BSOOB Transit RFP # 2023 -915-1
Transit Facility Feasibility Assessment and Design
Addendum 1 – October 23, 2023

STANDARD BOUNDARY SURVEY & EXISTING CONDITIONS PLAN
LAND OF
BIDDEFORD-SACO-
OLD ORCHARD BEACH TRANSIT COMMITTEE
POMERLEAU ST
BIDDEFORD, MAINE

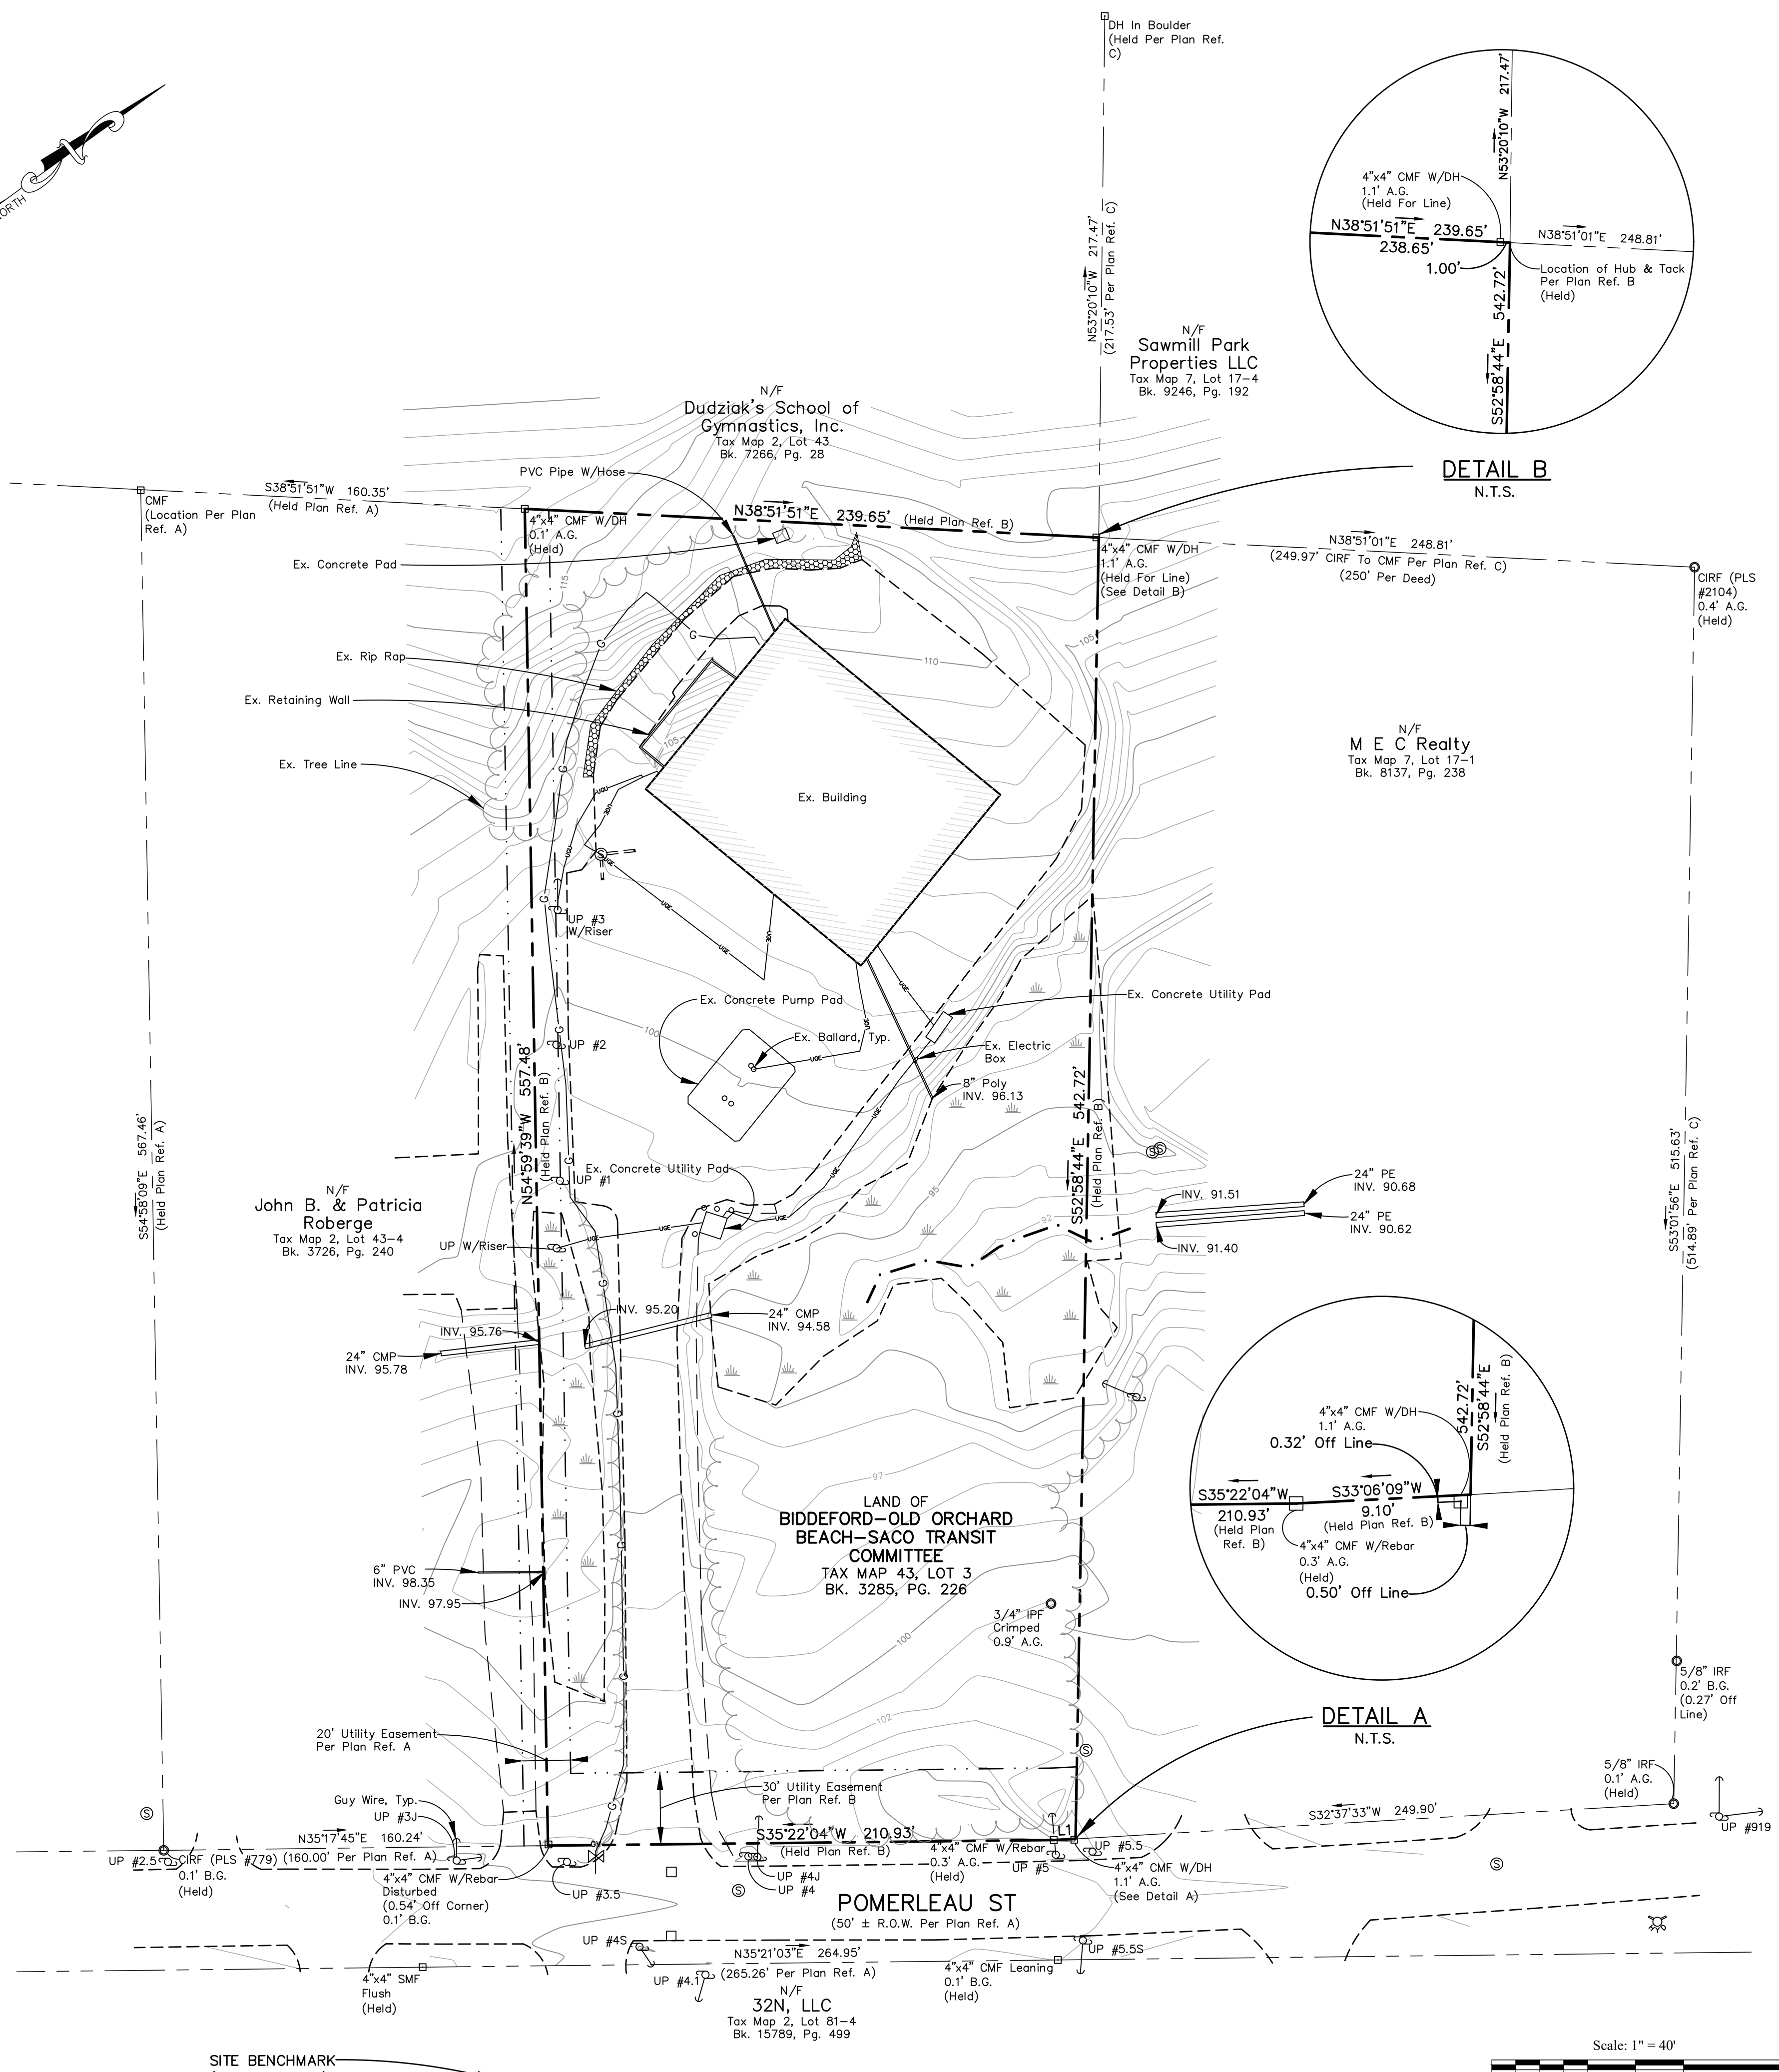
16. During the site visit it was discussed that there was a propane tank on site , was this above or below ground if below is it still there? How big was it ?

There isn't a propane tank on the property. We do have a natural gas line into the property that is located at the left rear corner. It is marked on the plan in purple.
